**CITY OF GRASS VALLEY
ENGINEERING DIVISION**

ADDENDUM NO. 1

**JOYCE DRIVE SOIL REMEDIATION PROJECT
PROJECT NO. 26-03**

PROJECT: JOYCE DRIVE SOIL REMEDIATION PROJECT
PROJECT NO. 26-03
BID OPENING: THURSDAY, JULY 30, 2026, AT 3:30PM

S2510-07-01 April 2026 Figure 12

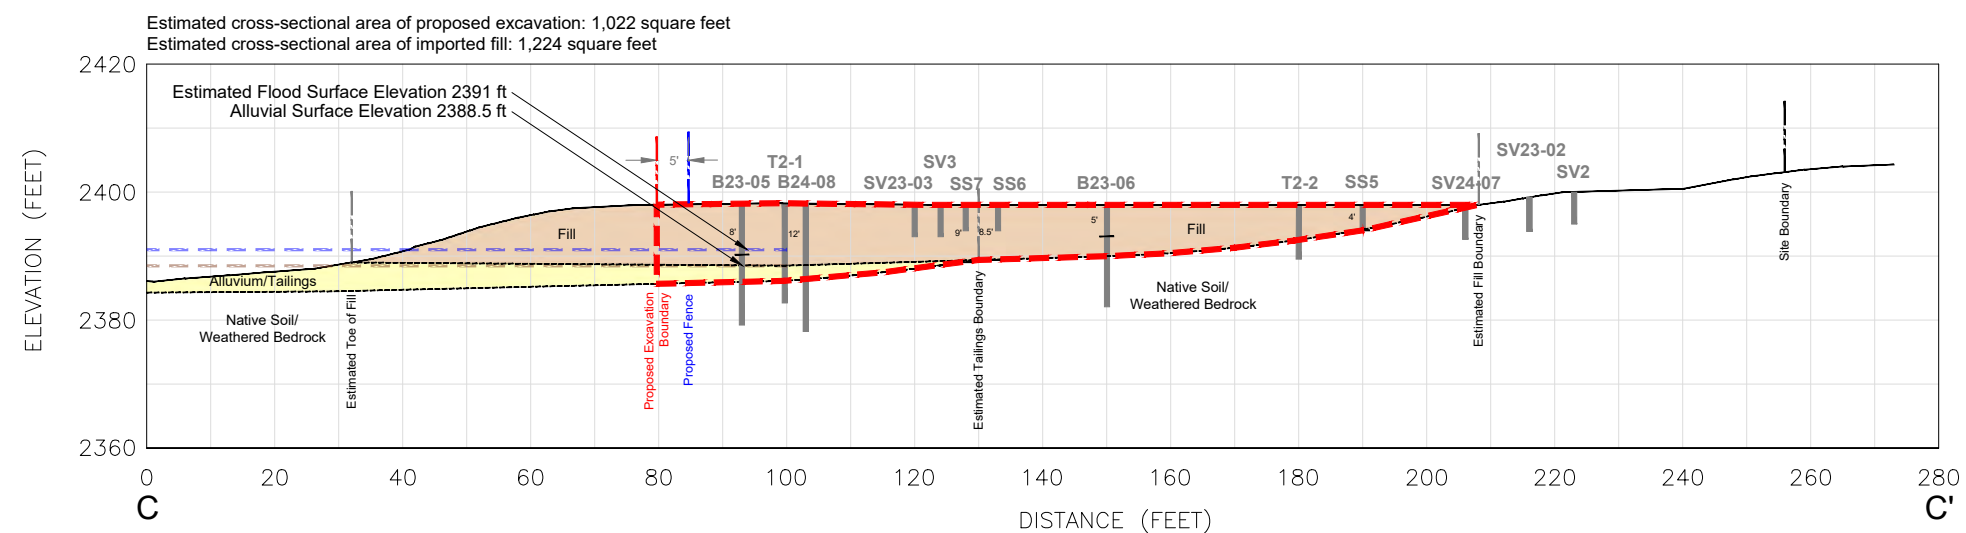
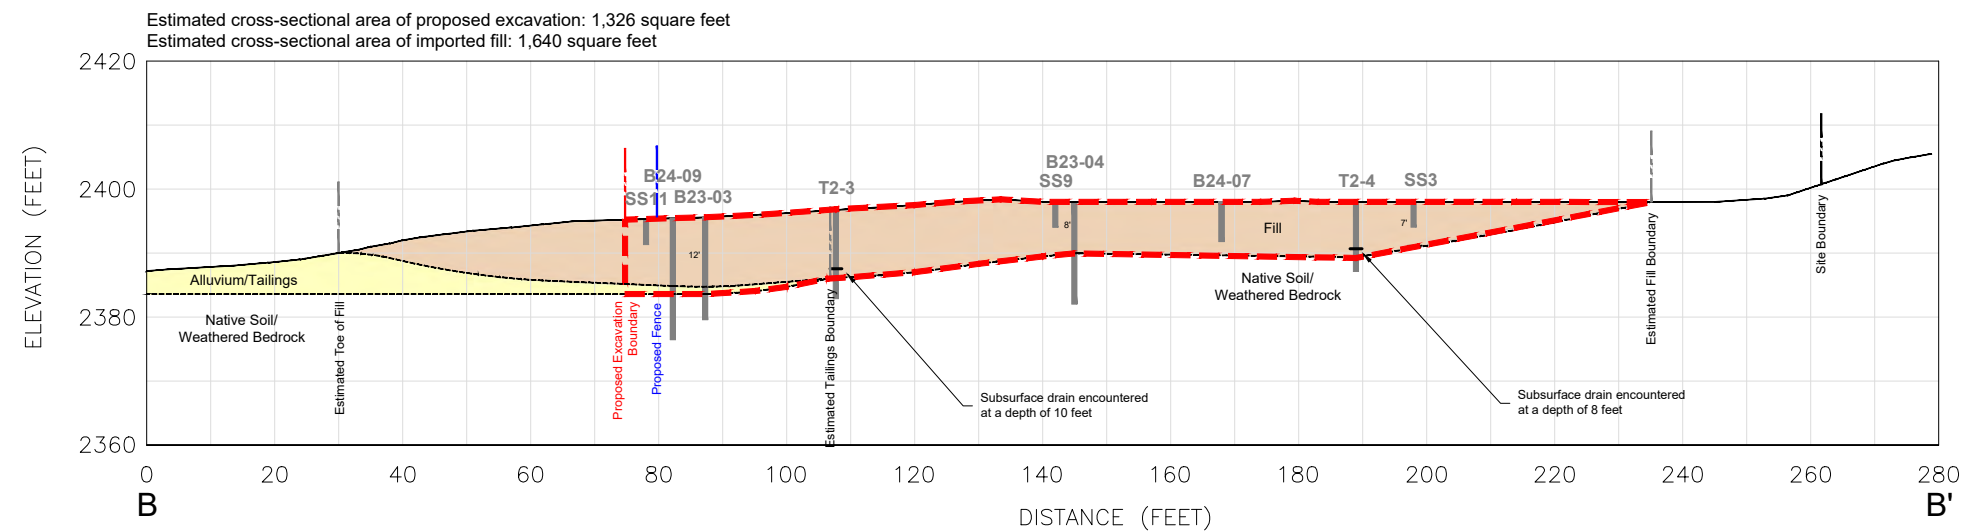
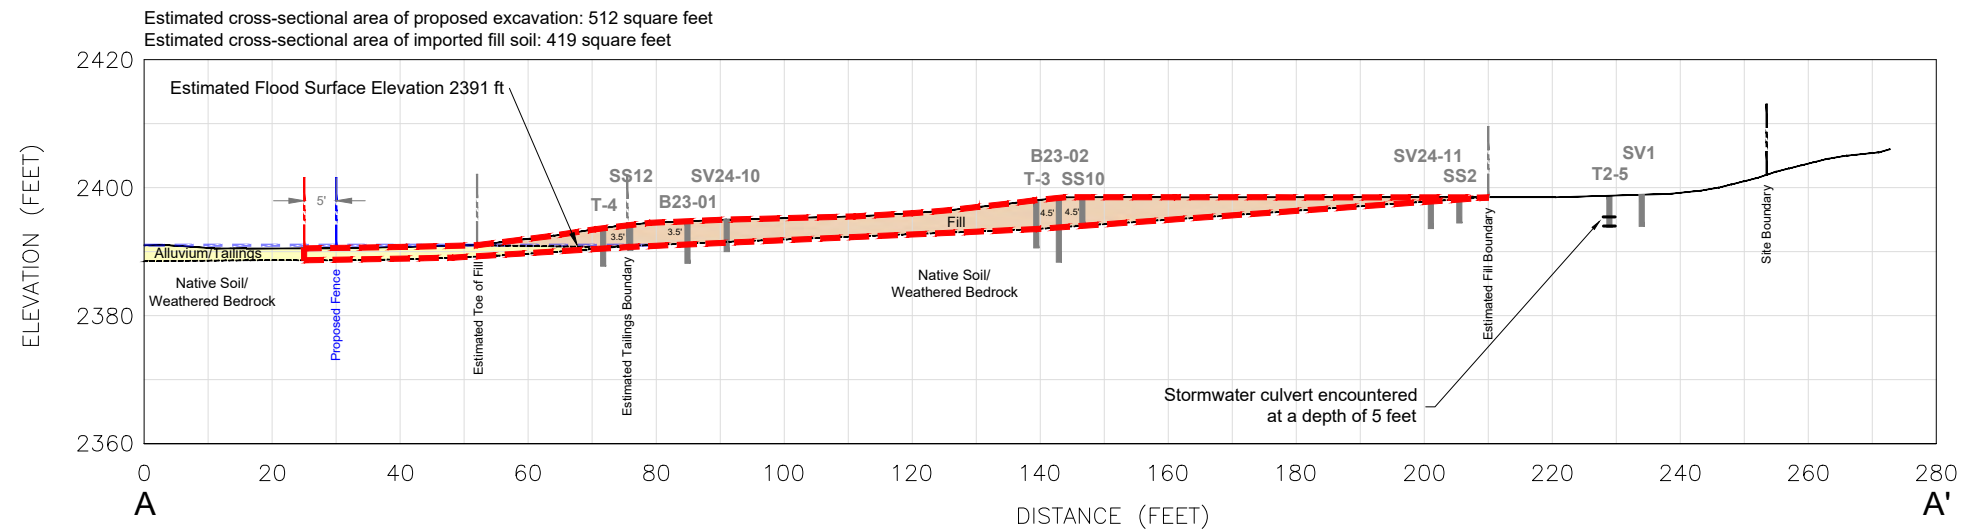
17. Refer to the Technical Specifications and the DTSC approved cleanup plan regarding excavation depths, fill slopes and volume quantities. Attached for easier reference are a volume estimate table and three figures from the cleanup plan which help depict expected excavation quantities. In accordance with Waste Disposal Items #3 and #4, excavation off haul will be paid per ton in the areas shown on the plans and as directed by the Engineer.

18. As shown in the cross sections, excavation up to a maximum depth of 12 feet is approximated. Temporary slopes are likely to be required at this and other locations. The slope gradient will be determined in the field based on the conditions observed in the slope face. A preliminary temporary slope of 1:1, horizontal to vertical, may be appropriate for planning purposes. Technical Specifications specify a maximum final 2:1 fill slope.
